Item Name: Crosstube Assembly, Mid Fwd

DART AEROSPACE LTD HAWKESBURY, ONTARIO, CANADA	
DRAWING NO. D206-667-147	REV. A SHEET 1 OF 4
TITLE CROSSTUBE ASSY (206L MID FWD)	SCALE NTS

DRAWING NO. D206-667-147	TITLE CROSSTUBE ASS'Y (206L MID FWD)	REV. A	<b>DART AEROSPACE LTD ENGINEERING ORDER</b>		D.E.O. NO. D206-667-147-A-1	SHEET NO. SHEET 1 OF 1	SCALE NTS
DRAWN <i>q</i>	CHECKED <i>ASS</i>	MFG. APPR. <i>JB</i>	APPROVED <i>MD</i>		DE APPR. <i>MD</i>		
DATE 11.07.15	DATE 11.07.20	DATE 11.07.21	DATE 11.07.21		DATE 11.07.21

REPLACE MAGNOBOND WITH PROSEAL.

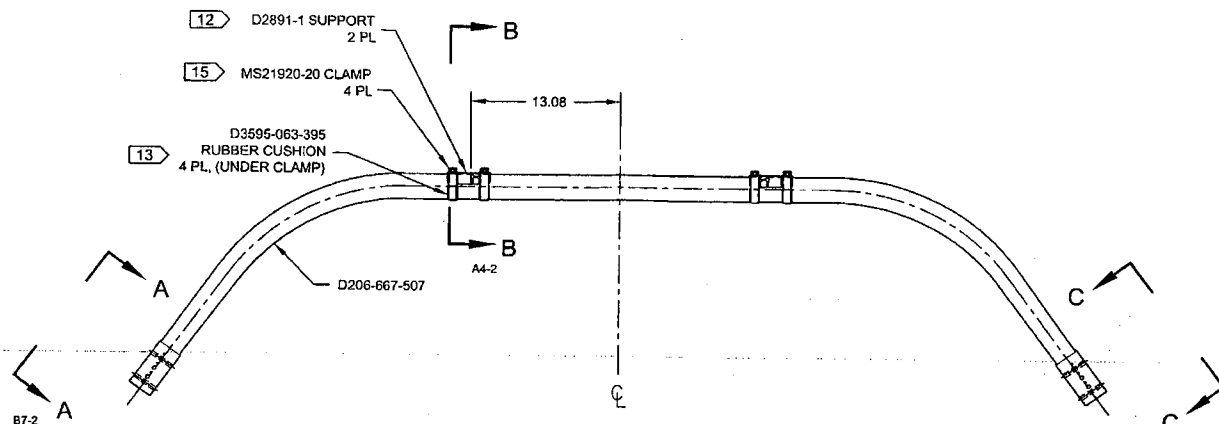
**PURPOSE:**

NOTE 12 & 15, SHEET 1 IS AMENDED AS FOLLOWS:

Item	Qty -147	Part Number	Description
9	A/R	PROSEAL 890 B-2	SEALANT, AMS-S-8802 CLASS B-2

- 12) TO INSTALL D2891-1 SUPPORT: ABRASE MATING SURFACE OF SUPPORT AND CROSSTUBE WITH 180-GRIT SANDPAPER AND REMOVE RESIDUE WITH MEK (OR EQUIVALENT). APPLY A 0.04" TO 0.07" THICK LAYER OF PROSEAL 890 CLASS B-2 (OR AMS-S-8802 CLASS B-2) SEALANT TO MATING SURFACE OF SUPPORT.
- 15) TORQUE CLAMPS 80 TO 100 IN-LB. ENSURE AT LEAST 1.5 THREADS SHOWING IN SAFETY AND THAT NUT HAS NOT BOTTOMED-OUT AFTER TORQUING. **PRIOR TO PACKAGING, RE-CHECK TORQUE ON CLAMPS AFTER PROSEAL 890 SEALANT HAS CURED FOR 72 HOURS.**
